Service information

Reference no.: SDA_81231

Twisting / blockage / leakage of linen-faced silicone tube in Incanto and Royal

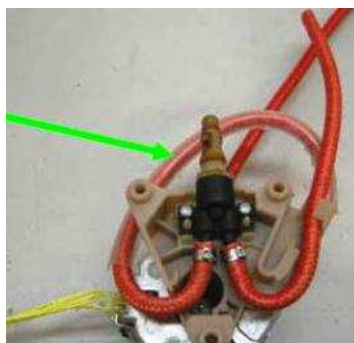
Twisting / blockage / leakage of the linen-faced silicone tube in Incanto and Royal series.

Incanto series till the serial number: 9008SA40289955 and Royal till the serial number: 9009ROY0730752.

Incanto and Royal: Insert a new longer tube (L= 290 mm; part code: 11001208) from boiler to boiler's pin positioning it correctly as shown in the image 1 and 2 in order to avoid the bending, and add a protective sheath (code 11010624).

Royal Professional: Insert a new red tube (L = 240 mm; part code:11000756) from pump to boiler positioning it correctly in order to avoid bending, and insert also a new transparent tube (L = 200 mm; part code: 9972.166) from the safety valve to the discharge in the drip tray as shown in the picture 3.
